### Proposed Revisions to a Standard Plans Index

Index Number: 521-620

Index Title: Concrete Barrier/Raised Sidewalk - Wall Coping

**TYPICAL SECTION THRU PRECAST COPING WITH C-I-P RAISED SIDEWALK AND RETAINING WALL AT EXPANSION JOINTS (32" Vertical Shape Shown, 42" Vertical Shape Similar)**

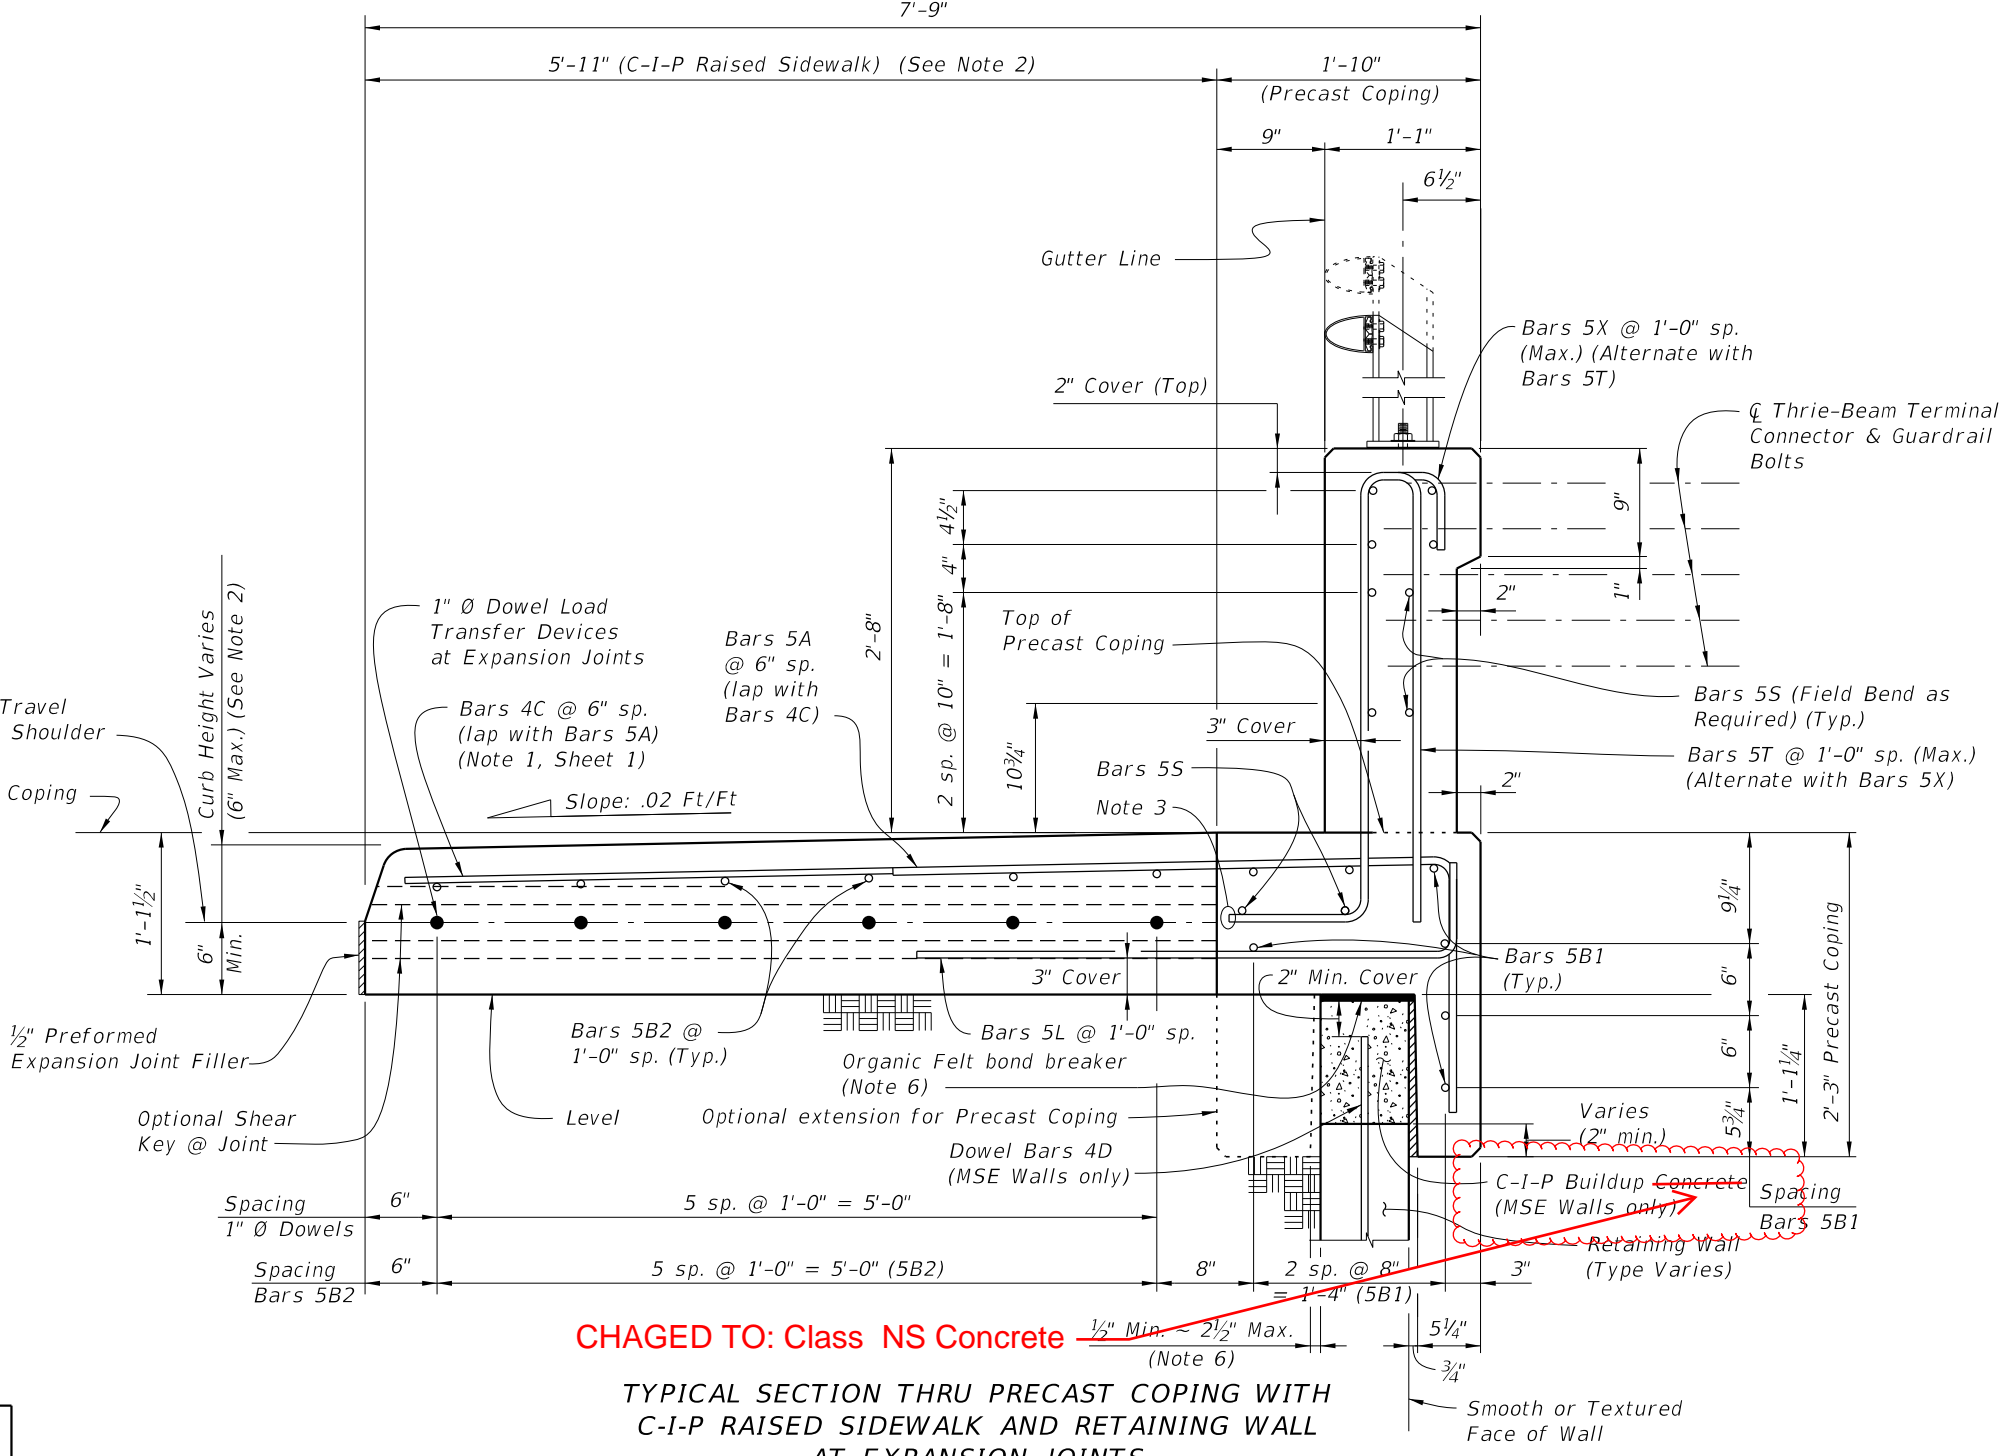
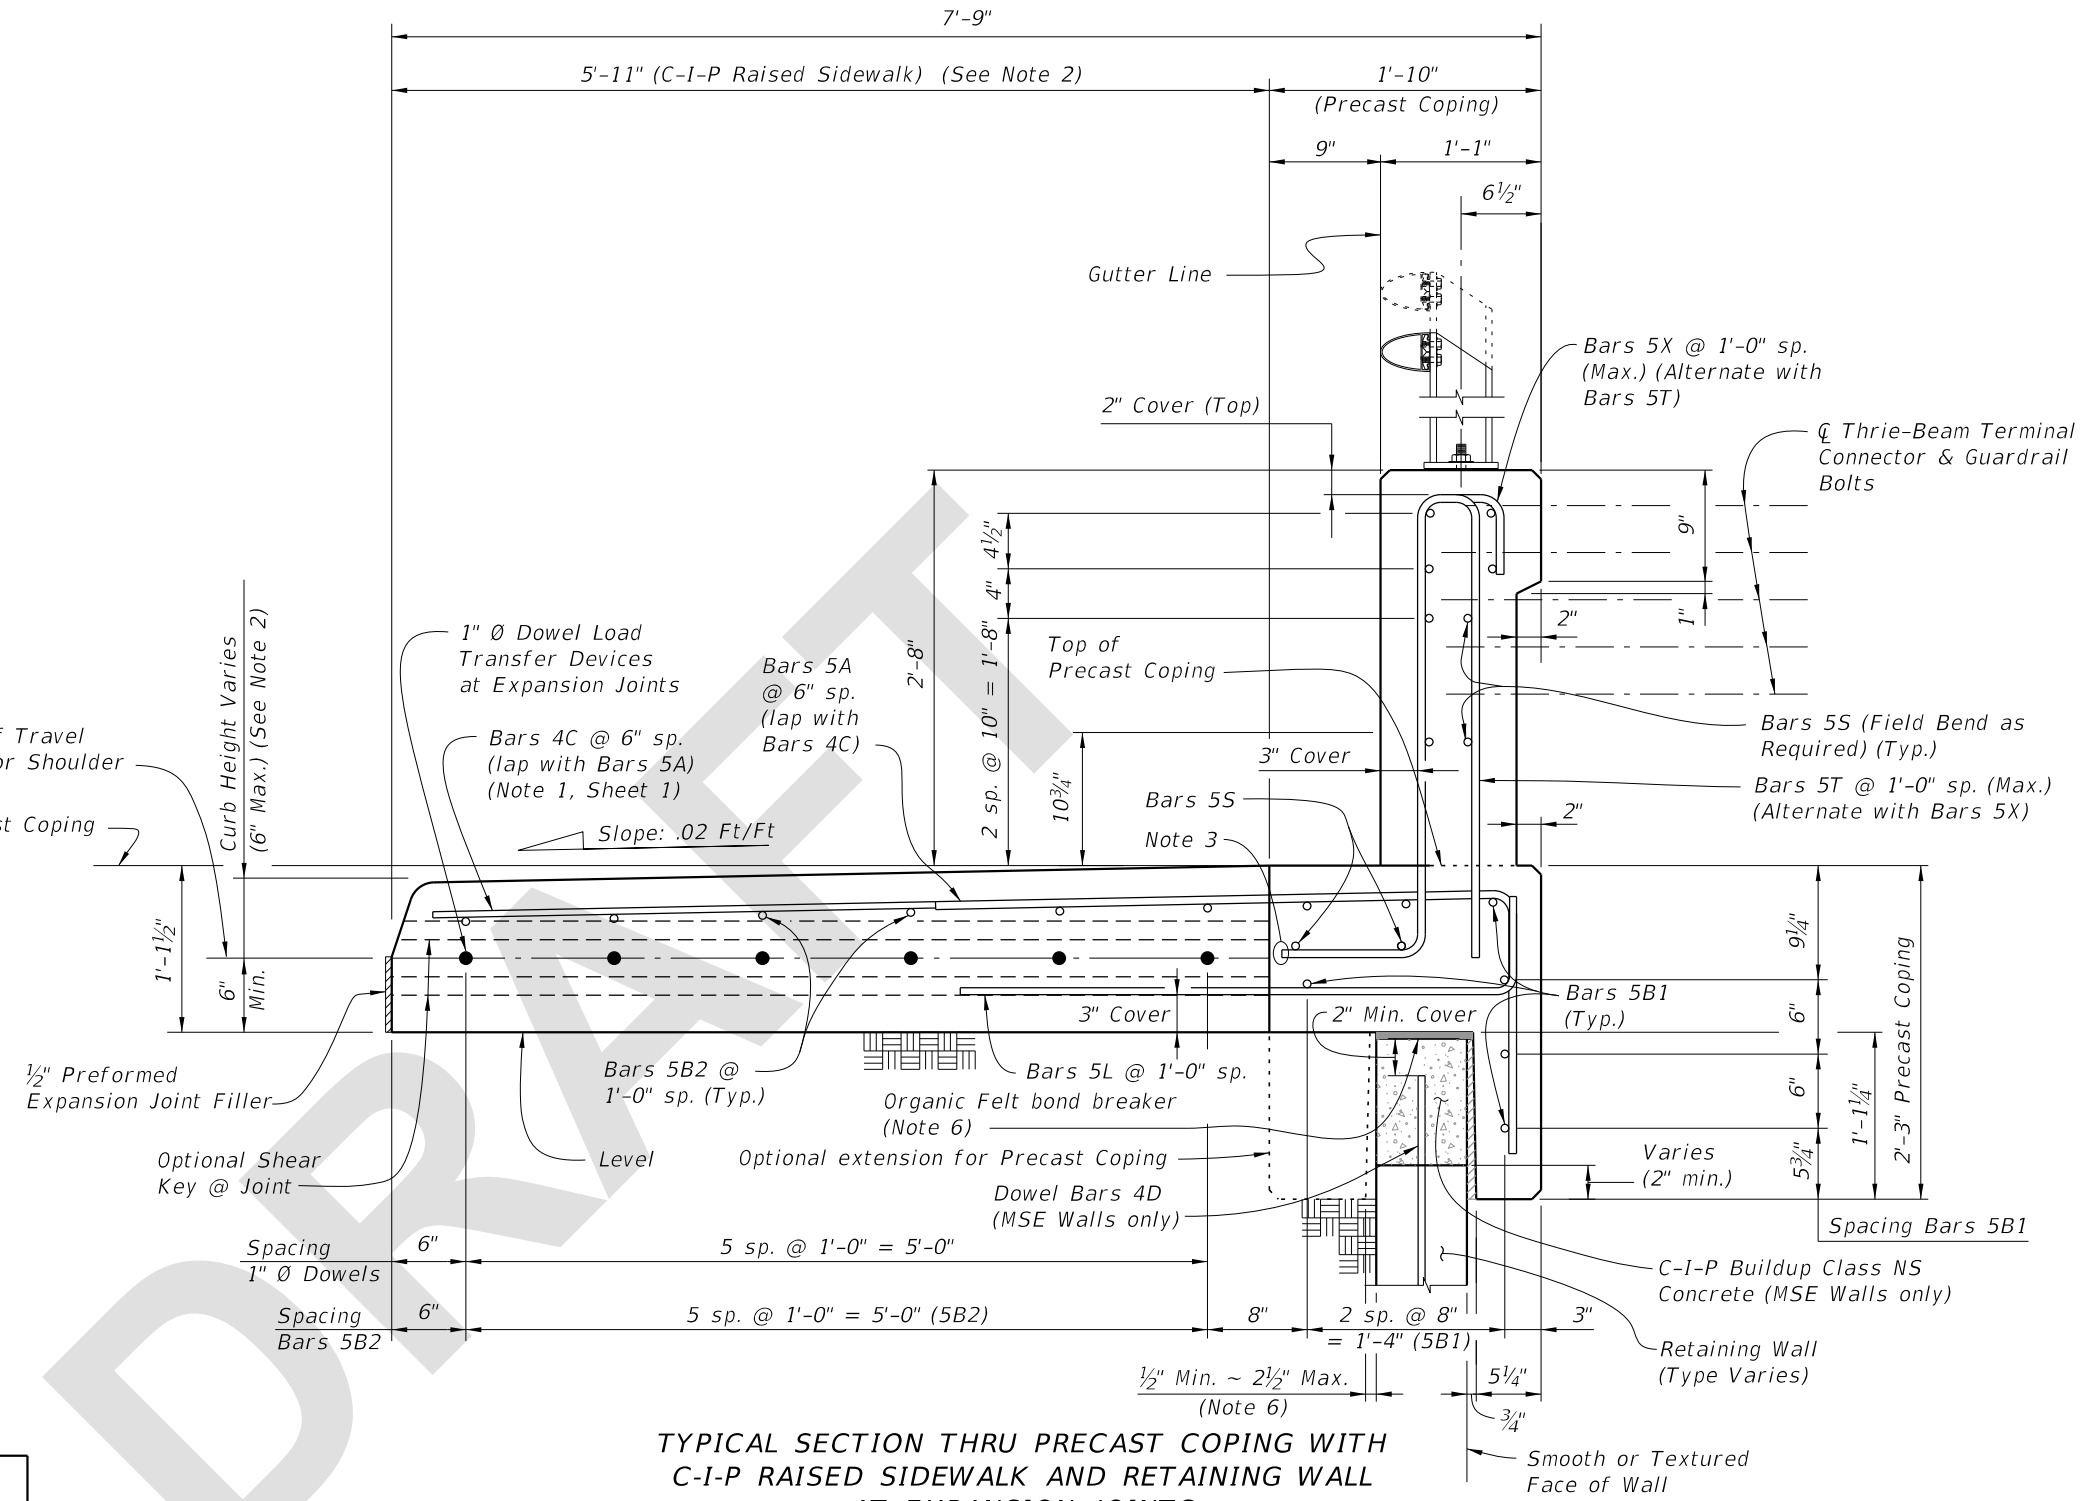
Changed C-I-P Buildup Concrete (1'-1" Max.) callout in the TYPICAL SECTION THRU PRECAST COPING WITH C-I-P RAISED SIDEWALK AND RETAINING WALL AT EXPANSION JOINTS to C-I-P Class NS Concrete (1'-1" Max.).

CIP buildup concrete type was never clarified. SDO review deems Class NS is acceptable because the concrete buildup section is not meant to transfer any meaningful load to the wall other than self weight.

**CHANGED TO: Class NS Concrete**  $\frac{1}{2}$ " Min. ~  $2\frac{1}{2}$ " Max. (Note 6)
